**Report Type:** SSDA Access Report

**Site Address:** Saints Peter and Paul Assyrian Primary School at  
17-19 Kosovich Pl, Cecil Park

# ACCESS REPORT

This Access Compliance Report is to accompany a State Significant Development Application (SSDA) for the development proposed at Saints Peter and Paul Assyrian Primary School at 17-19 Kosovich Pl, Cecil Park

Entry Option 1 shown above

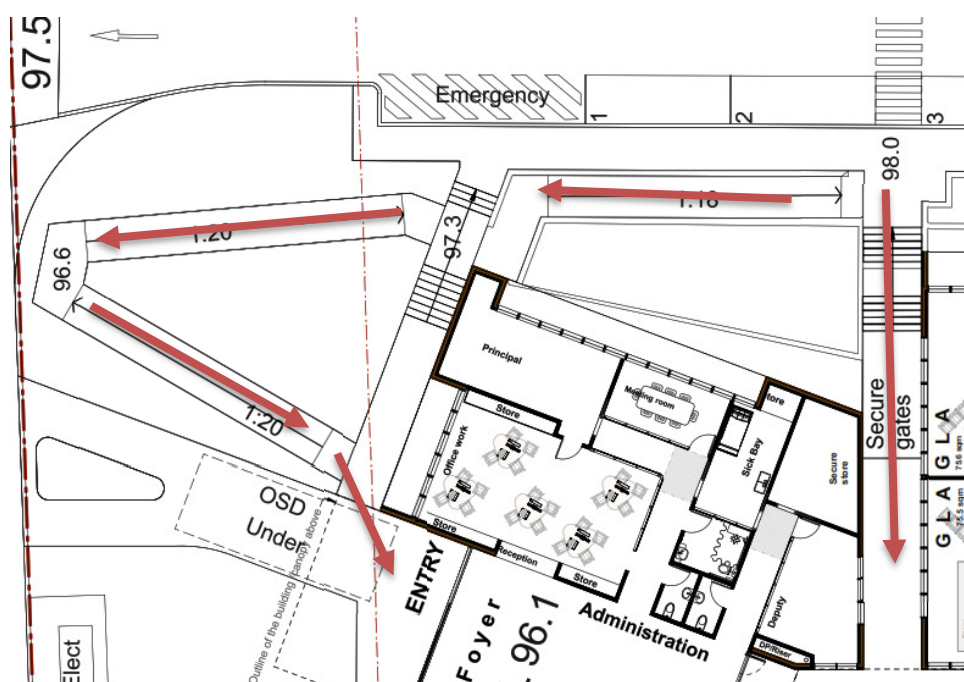
BCA D3.1 General building Access requirements
<b>Requirement</b>	<b>Class 9b- Schools and early childhood centres.</b> - To and within all areas that are normally used by the occupants.
<b>Compliance Comments</b>	Complies. Access has been provided to and within all areas required to be accessible. Details to be verified at CC stage of works.
	BCA Part D3.2 Access to buildings
<b>Requirement</b>	<b>Accessway is required from;</b> - Main pedestrian entry at the site boundary for new buildings. - Any other accessible building connected by a pedestrian link. - Accessible car parking spaces.
<b>Compliance Comments</b>	Complies. A level pedestrian entry has been provided from the main pedestrian entry at the site boundary. The buildings are interconnected by means of 1:20 grade walkways, 1:18 and 1:14 grade ramps (note that any ramps grades steeper than 1:20 and less than or equal to 1:14 is to be compliant with ramp requirements of AS1428.1-2009)

Entry Options 2 and 3 shown above from kiss and run

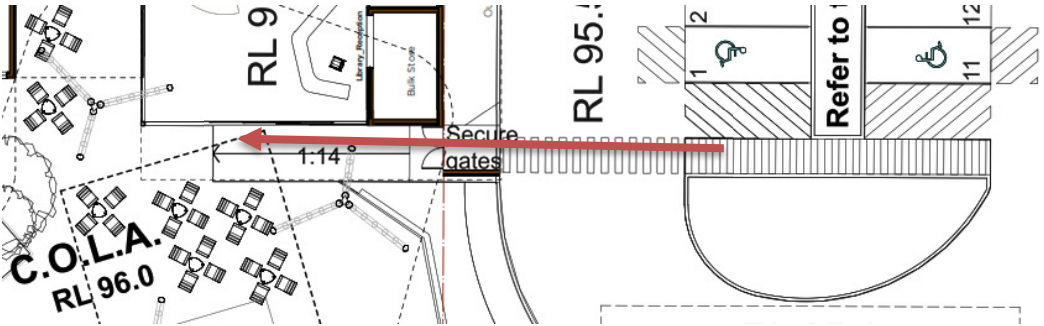
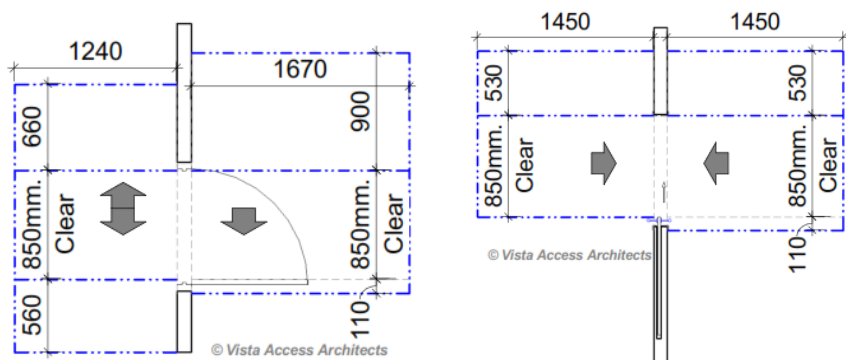
<p>- Access has been provided from accessible car parking spaces by means of 1:14 grade ramp.</p>  <p><b>Entry Options 4 shown above from Accessible parking spaces.</b></p> <p>Details to be verified at CC stage of works.</p>
<b>Requirement</b>	<p><b>External Walkway / Pedestrian access requirements as per AS1428-2009:</b></p> <ul style="list-style-type: none"> <li>- Accessible path of travel to have a gradient no steeper than 1 in 20 and a cross fall no steeper than 1:40 (1:33 for bitumen).</li> <li>- For 1:20 grade walkways, landings are required every 15M.</li> <li>- The floor surface abutting the sides of the walkway to be provided with a firm and level surface (of a different material) at the same level and grade of the walkway, and extend horizontally for a minimum of 600mm unless one of the following is provided: kerb, kerb-rail and handrail or wall of minimum 450mm height.</li> </ul> <p>Curved walkways to be min 1500mm width with crossfall towards the centre of curvature.</p>
